Addendum to IFB

IFB TITLE: Crime Lab Vehicle Search/Investigation Building Renovation

ADDENDUM NO.: 1

ADDENDUM № 1

Project Number	JCVIB-23
Date	10/18/2023
Scale	1/4" = 1'-0"
DEMOLITION FLOOR PLAN

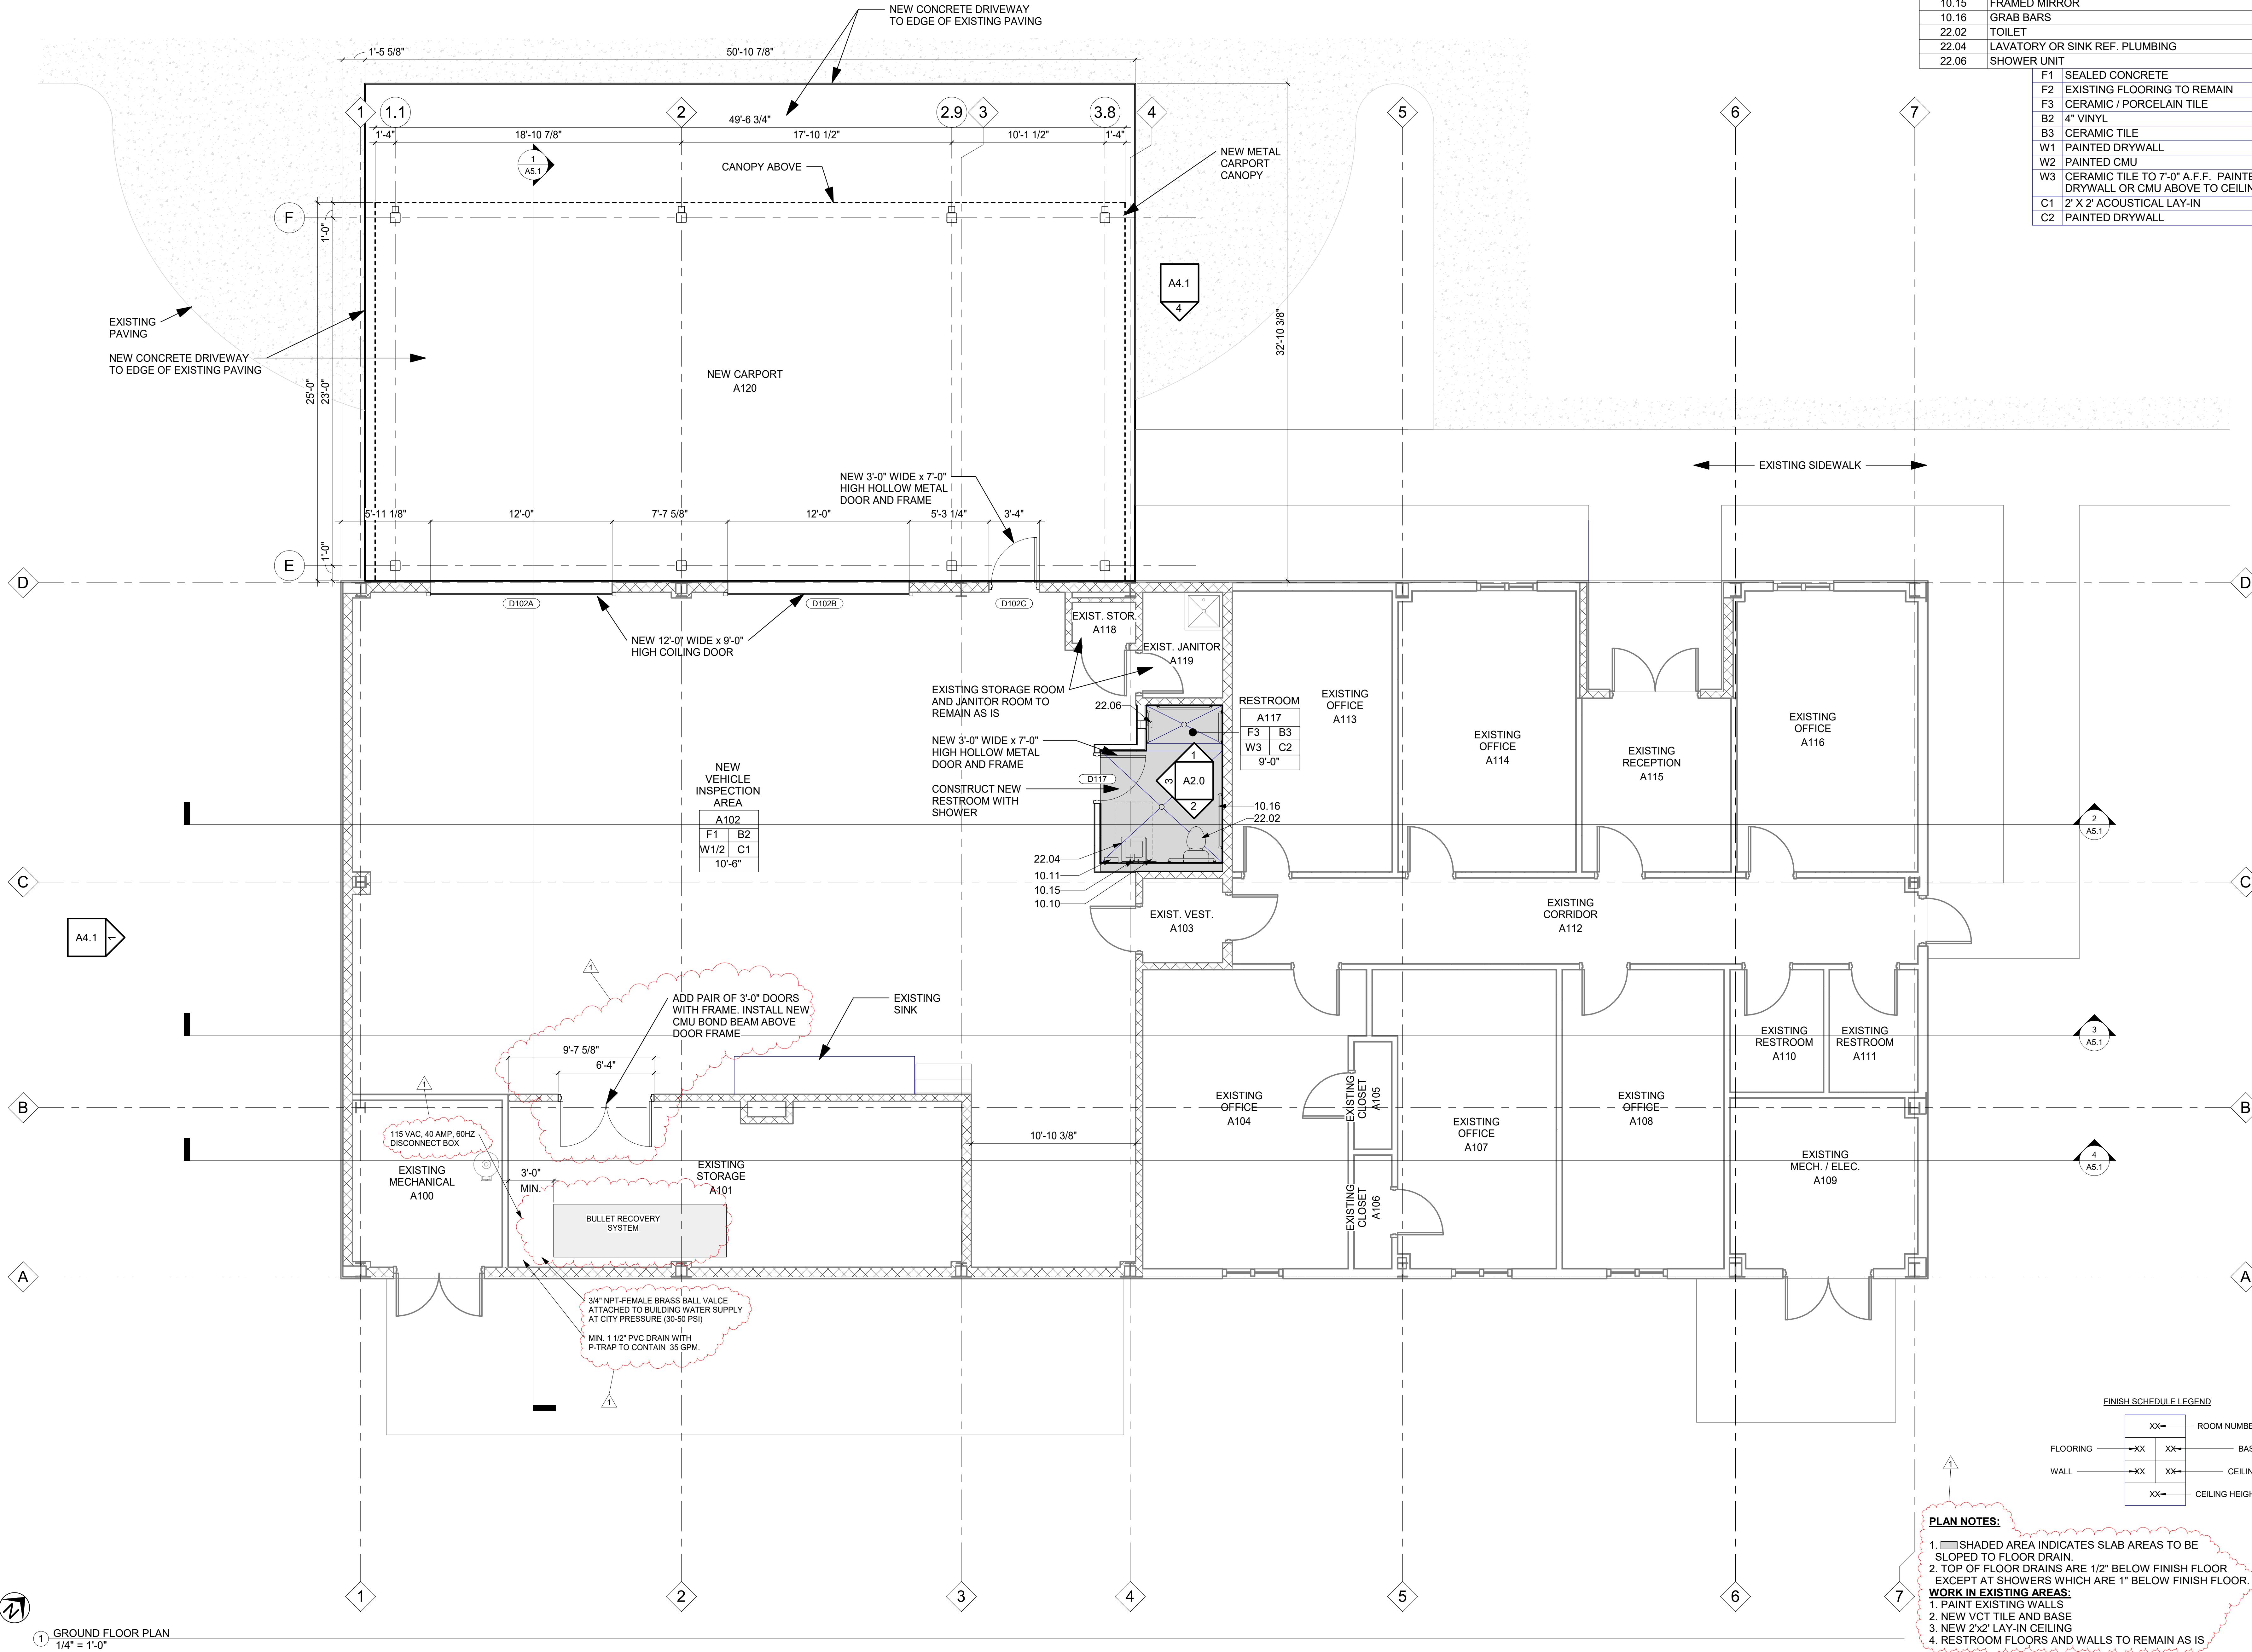
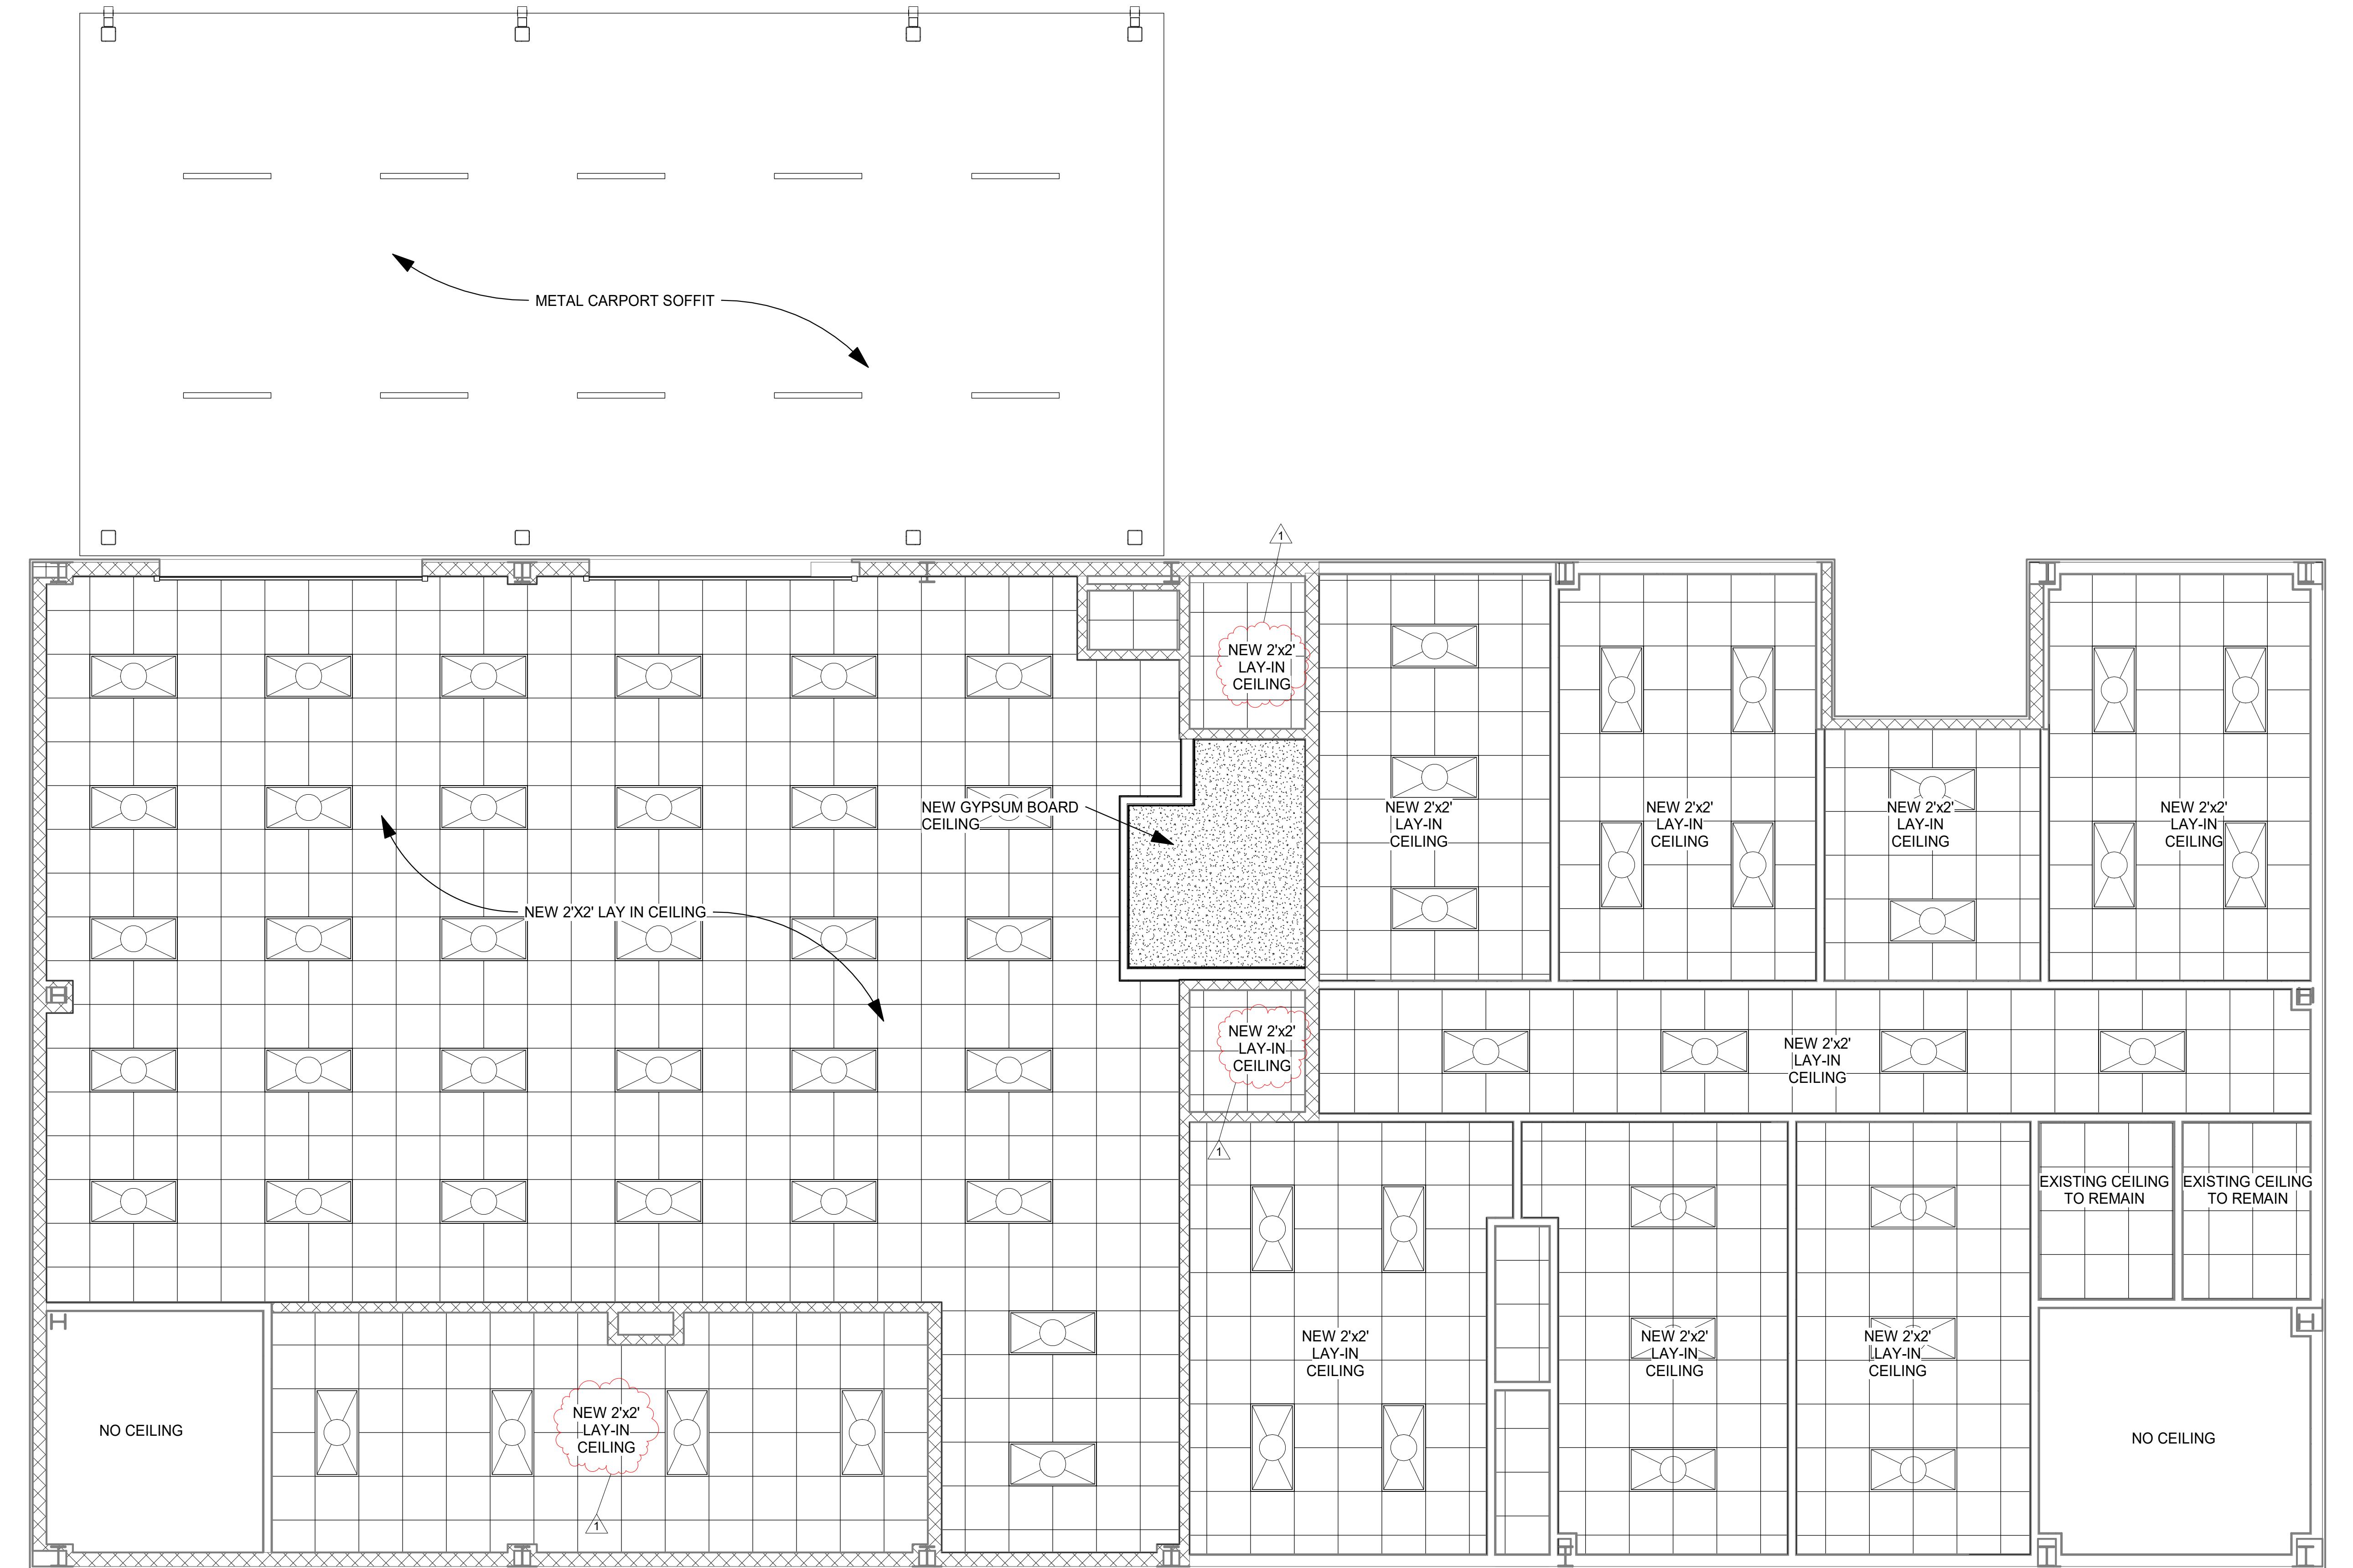
15.00	Can I get a complete "Finish" schedule for all the existing rooms?	Refer to plan notes on revised sheet A1.0.	ARCHITECTURAL	
16.00	Can we get a detail of what is required to fill the area where the in-floor scale is being removed. How deep is the area and what is below the scale?	Fill with cement stabilized sand or concrete at contractor's option. Pour 5" thick concrete topping slab flush with finished floor & use #4 rebar at 18" o.c. in both directions for reinforcing. Dowel slab reinforcing into existing foundation with 6" of embedment using an epoxy adhesive. Assume infill dimensions are 3'-0" L x 4'-0" W x 2'-0" D	STRUCTURAL

22.00	Are we painting all the hollow metal door frames in the existing office area ?	Yes.	ARCHITECTURAL	
23.00	Can we get a completed finish schedule listing the areas and surface to be painted on the exterior and interior. The specifications are confusing?	Refer to plan notes on revised sheet A1.0.	ARCHITECTURAL

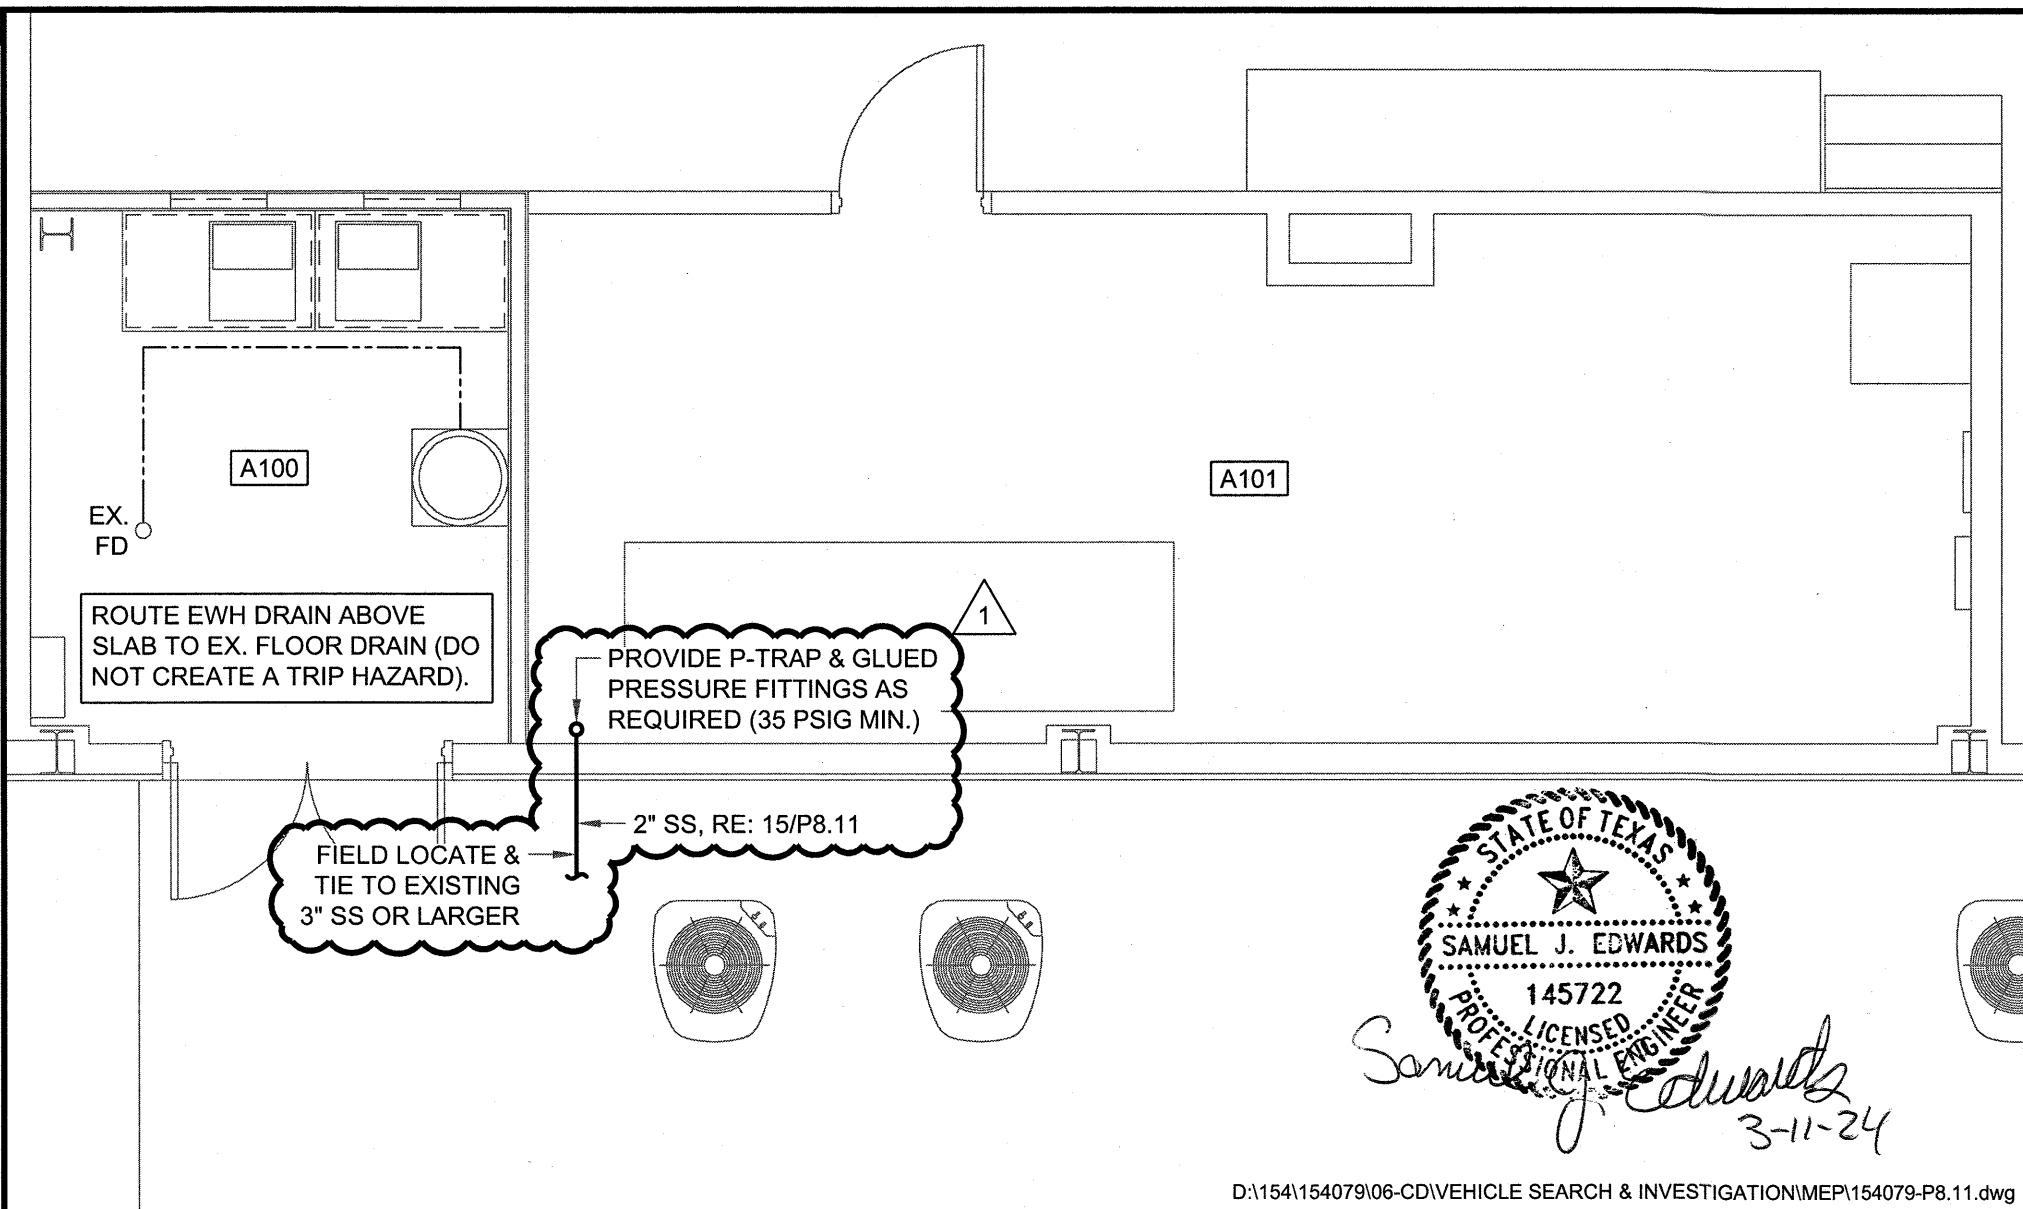
1. See attached Architectural drawings A0.2, A1.0, and A1.1.
2. See attached Civil sheets CS01, CS02, CS03, CS04 and CS05.
